This is to certify that PEARL PROPERTY LLC / Joe Reynolds *Structure &*
has permission to addition of a 4 story building on footprint. *SHELL ONLY*
AT 61 INDIA ST *CBL 020 E021001*

City of Portland, Maine - Building or Use Permit Application

RE: **61 India Street (rear)**
Application ID: **#2008-0116 (approved October, 2008 as revised December 2008)**

C1.1
revised 1/09

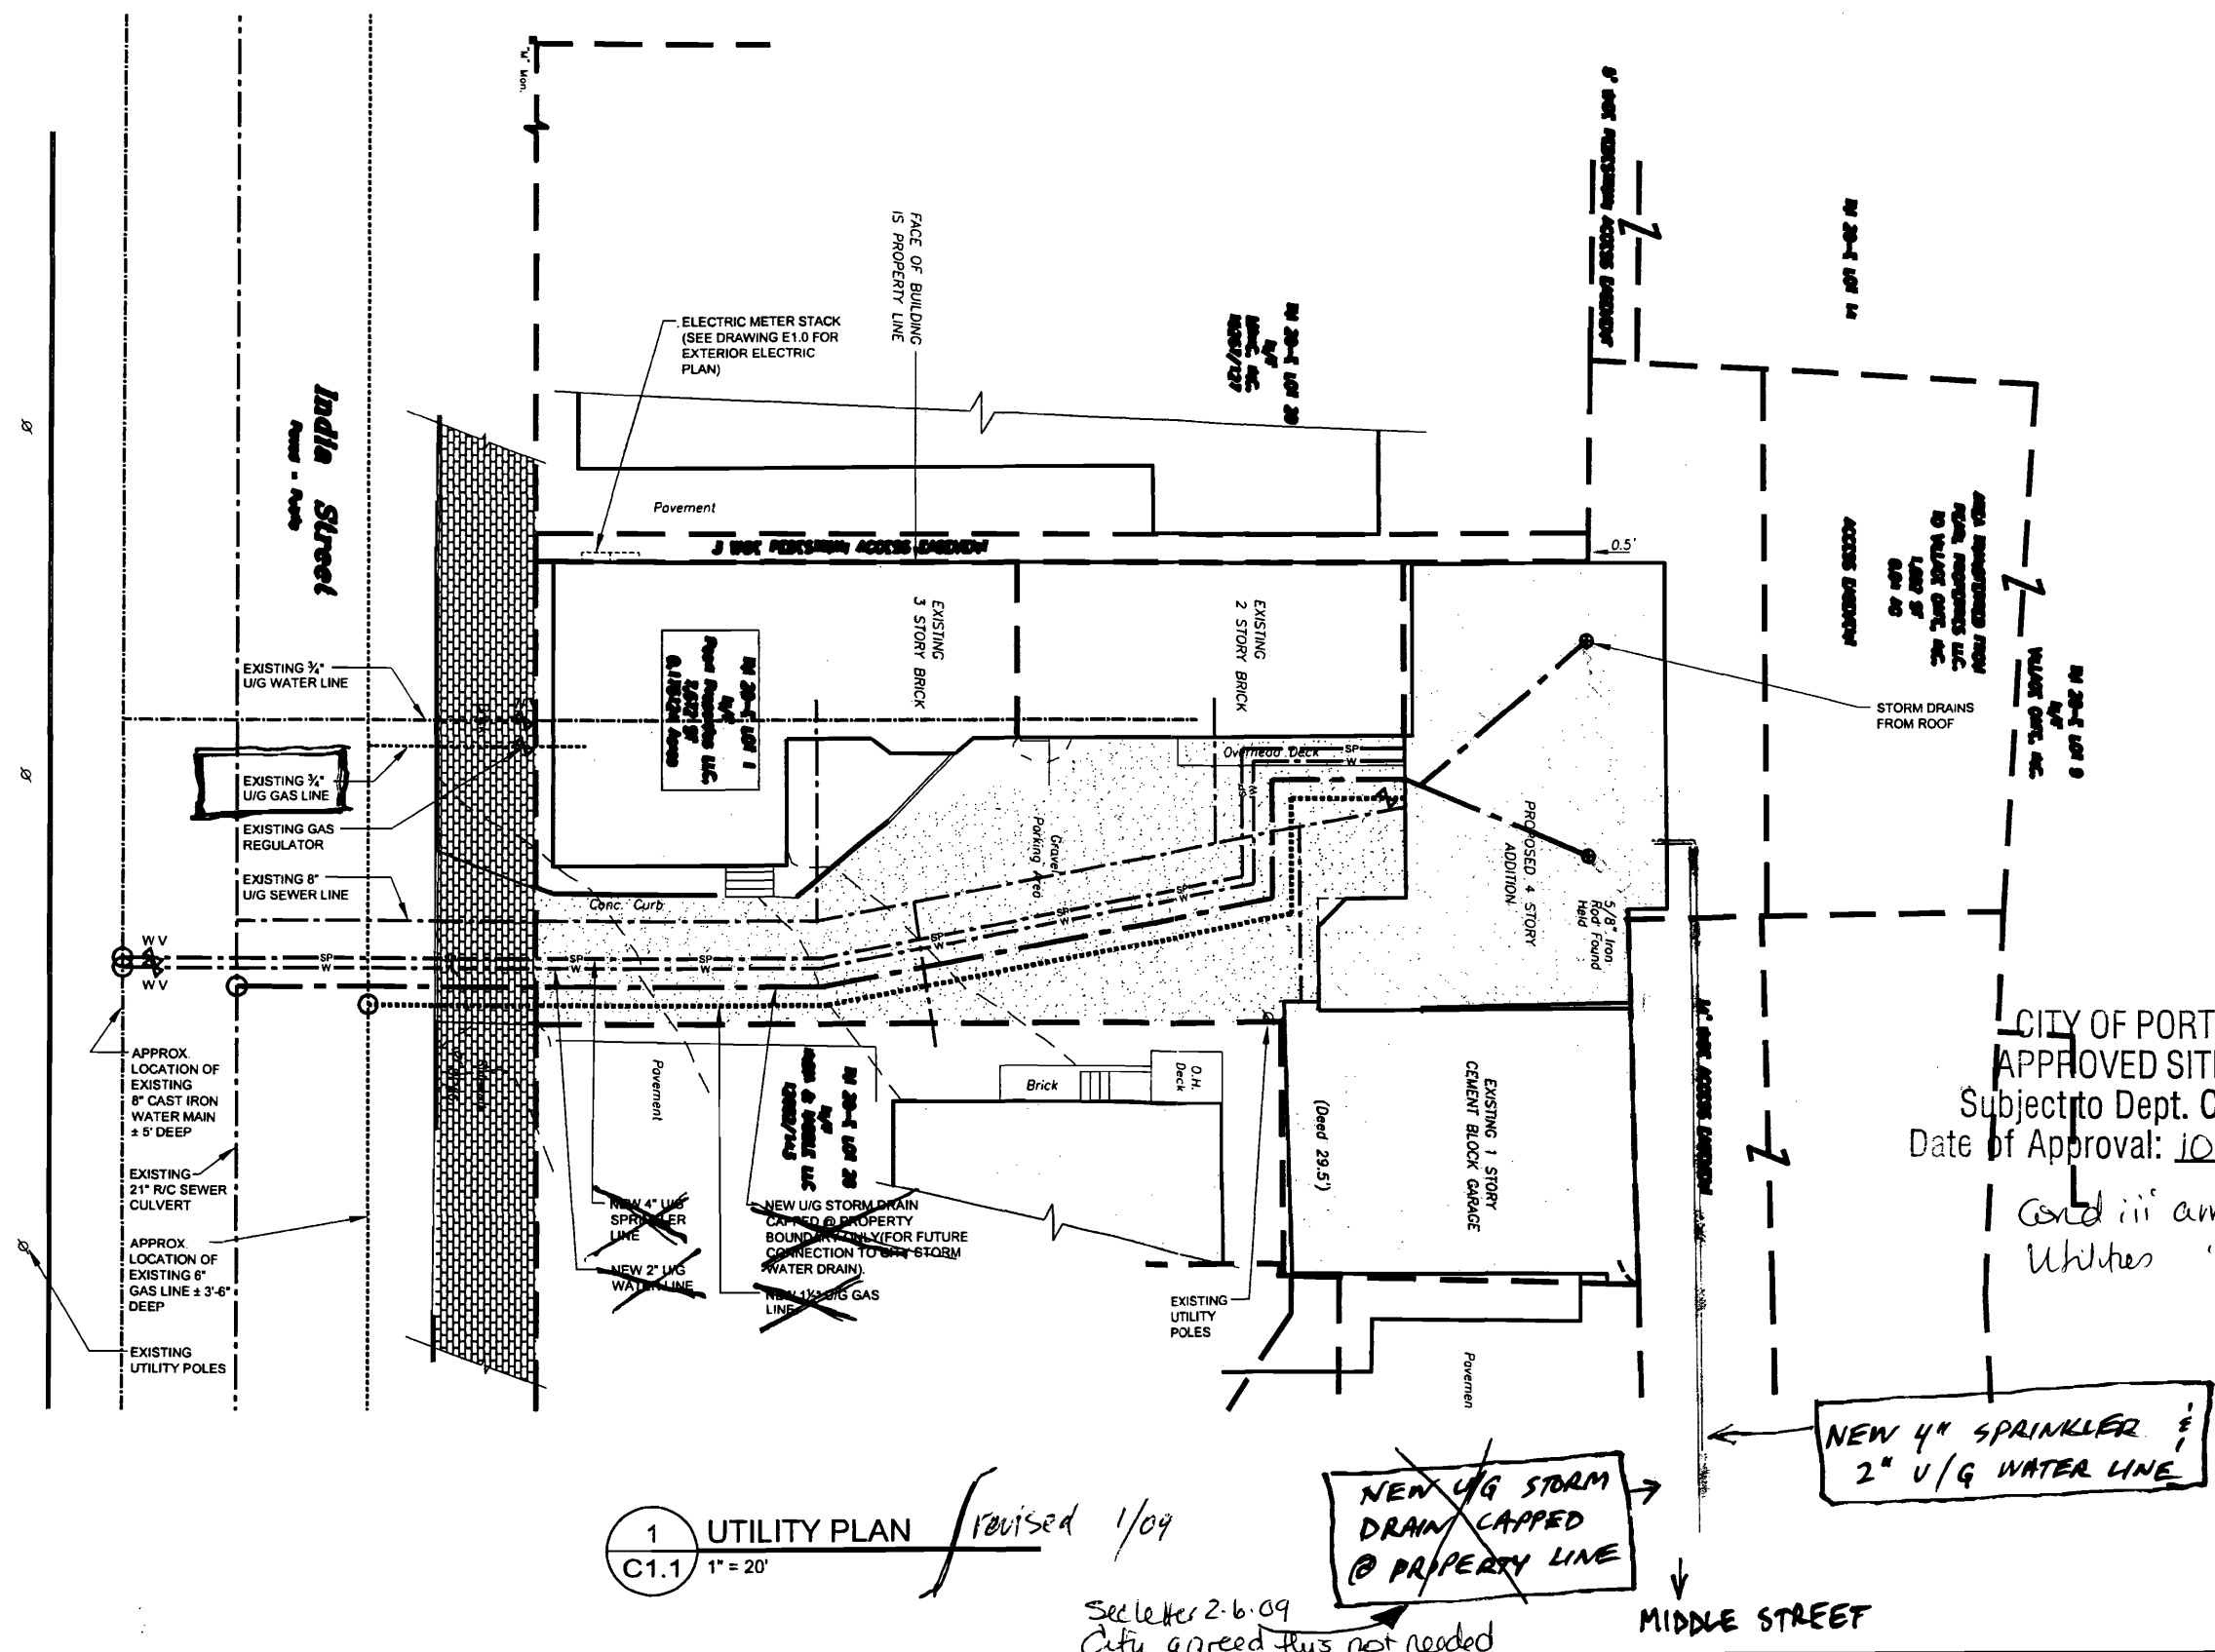
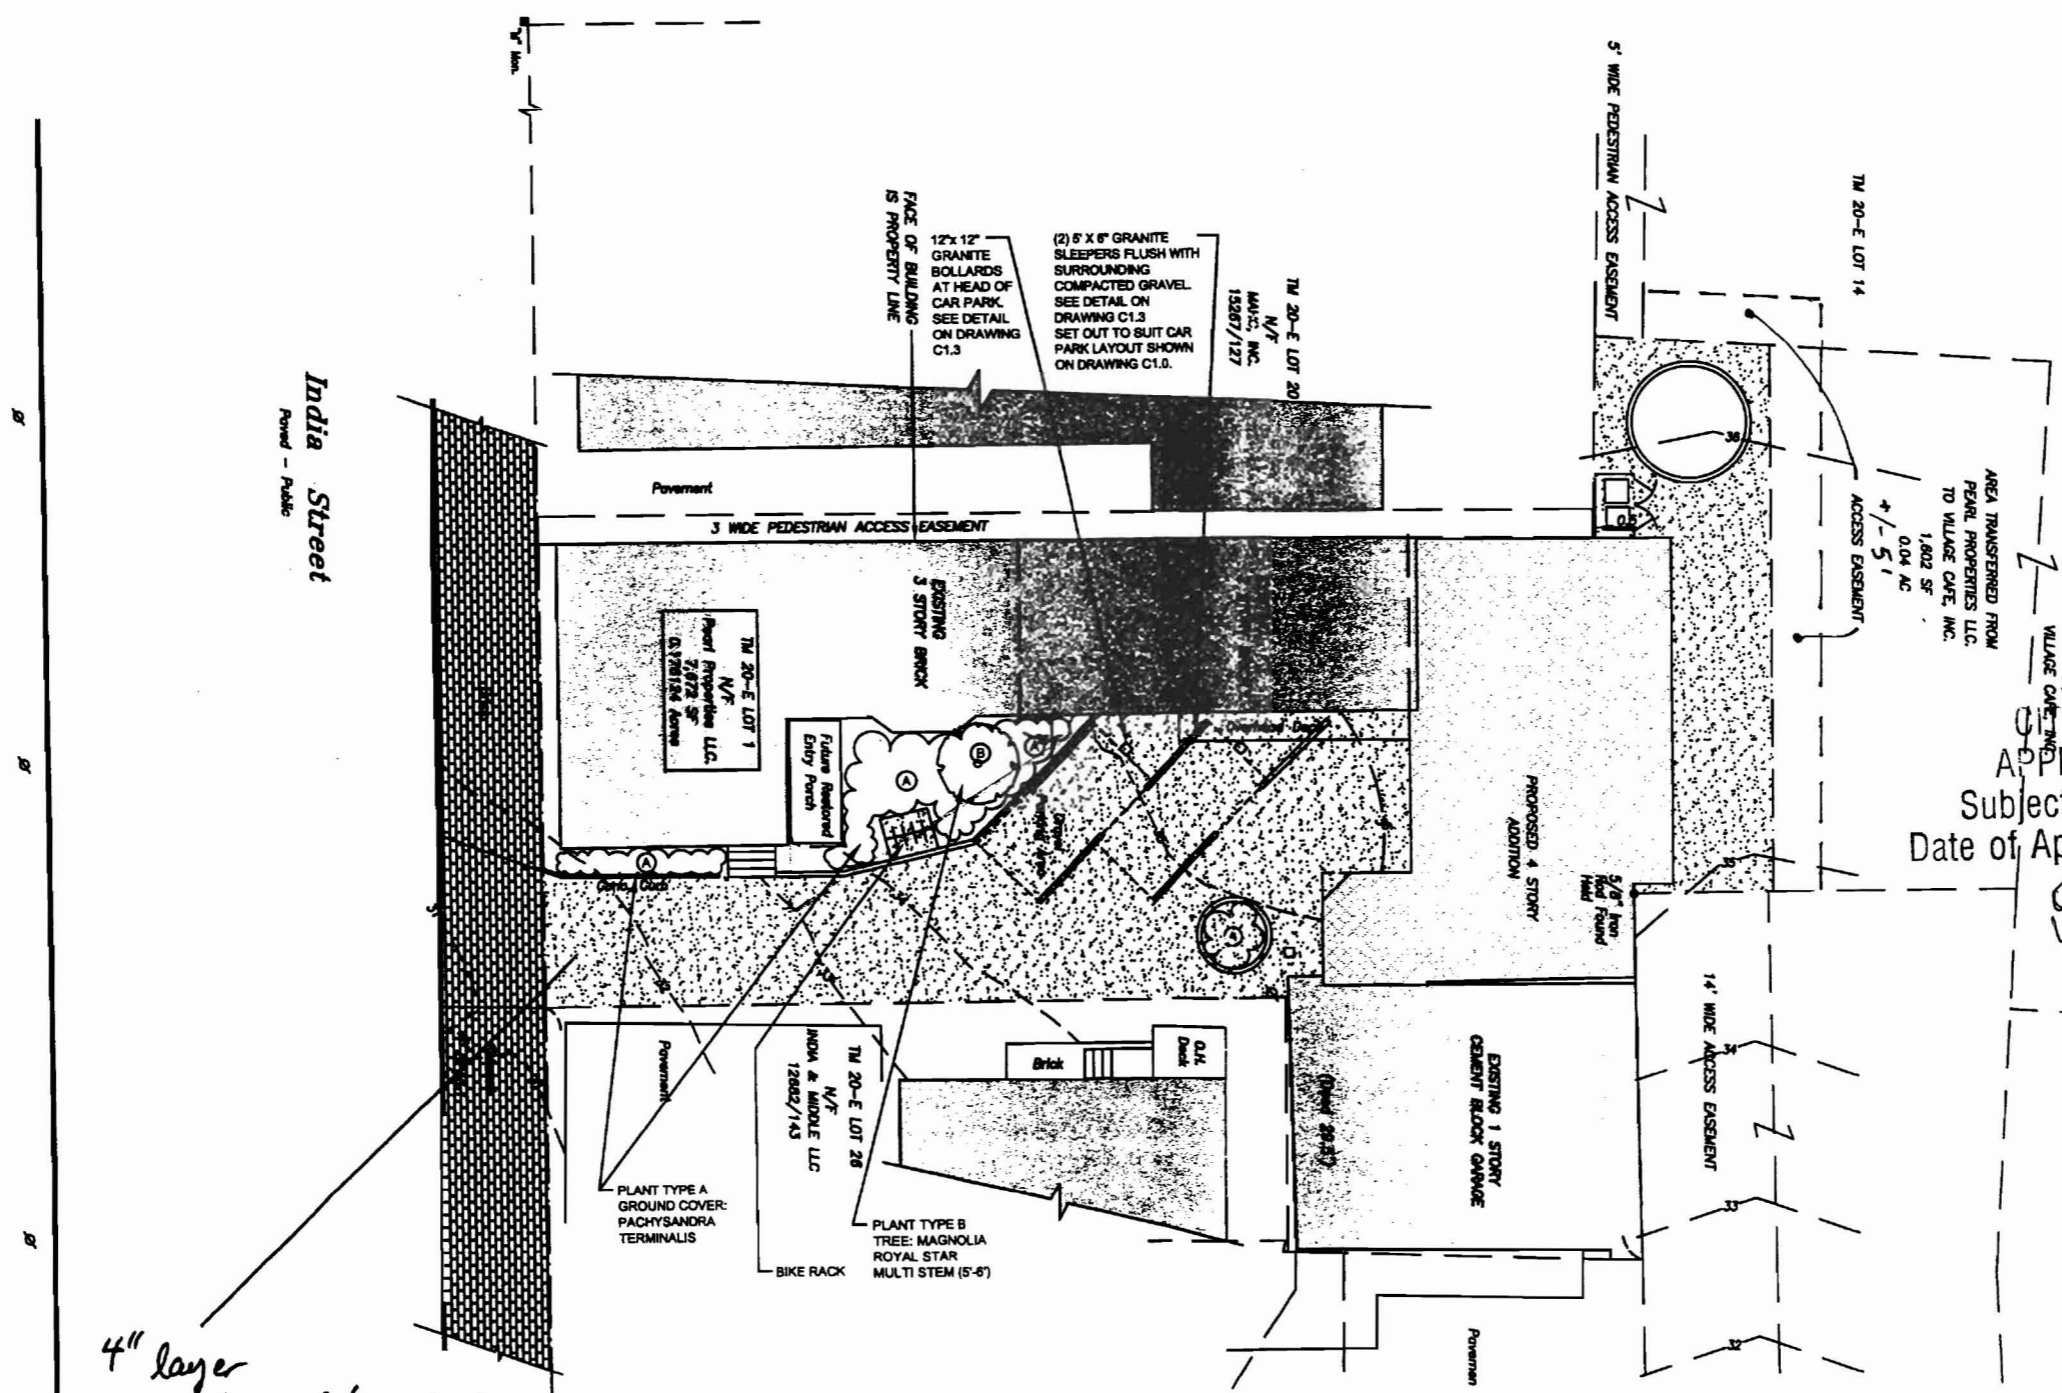
Thank you for letter and attached amended plan (hand annotated C1.1 Utility Plan "revised 1/09" showing revised locations of the water, gas and storm drain connections) dated January 28, 2009. I have discussed this proposed amendment to the approved project with Public Services Engineers and can confirm:

1. The City approves the relocation of the two water lines to tie into Middle Street and the use of the existing gas line in India Street (instead of the new gas line shown on the approved Utility Plan), and understand you will ensure the installations are acceptable to the relevant agencies.
2. The City approves the omission of the "New U/G storm drain capped @ property boundary" between the building and India Street.
3. The City does not require the "New U/G Storm Drain capped @ property line" shown on the amended plan between the building and Middle Street.
4. The City requires that the roof drains for the approved building construction shall discharge to the ground for surface flow and shall not be connected to the sewer lines in India Street nor in Middle Street.

This letter should be attached to the amended Plan C1.1 Utility Plan for future reference.

L1.0

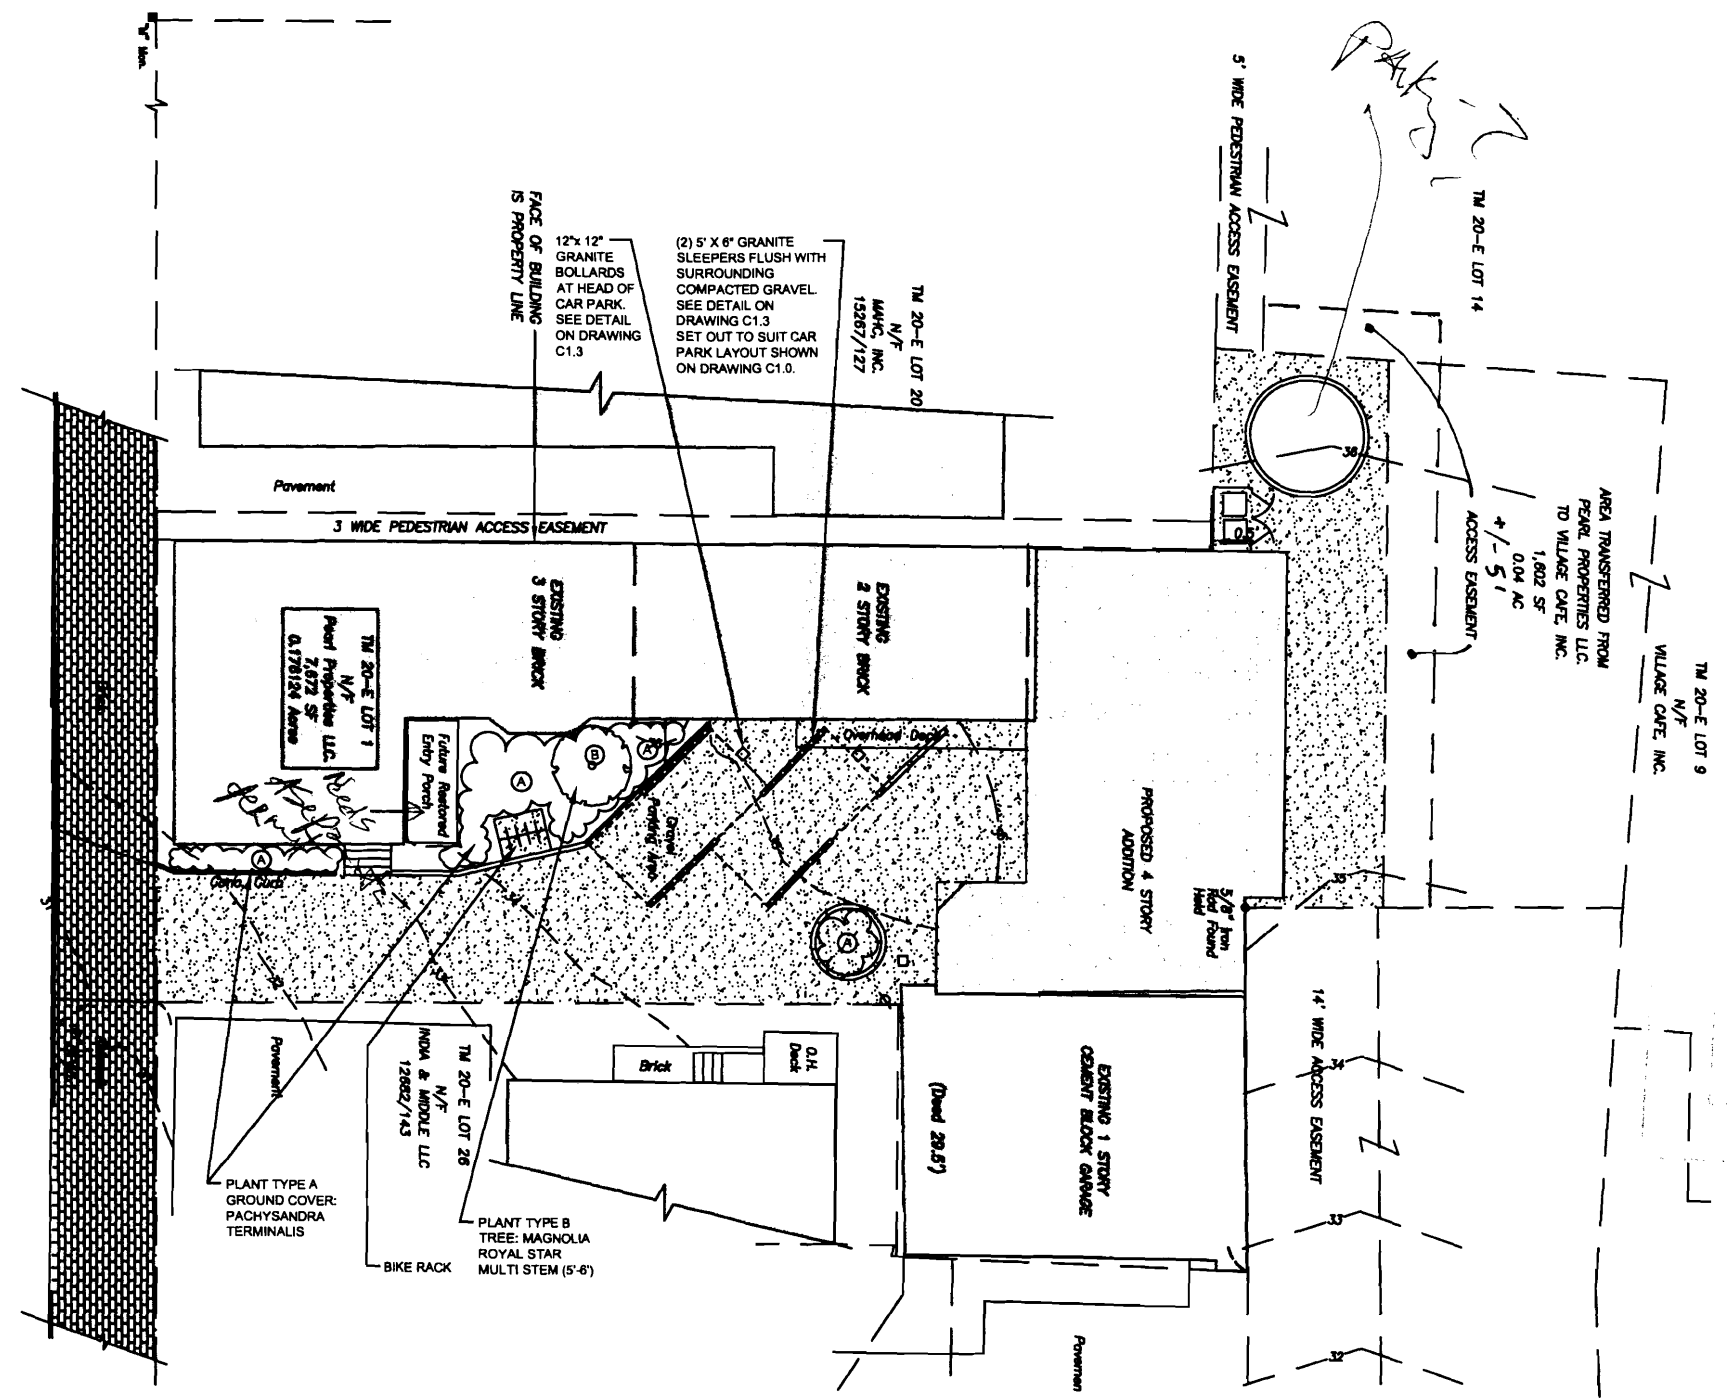
6. Revise Plan L1.0 to include details of proposed hard and soft landscaping, including size and species of planting (you might want to include a small bike rack tho' this is not a requirement);

6. See revised Plan L1.0.
7. See Attachment D.
8. See attached survey dated 8-15-08.
9. Before I confirm a commitment to contribute, I would like to know about the formula by which a contribution amount is derived. I would consider my development to have a minimal impact on traffic and would expect a contribution to be minimal, too.
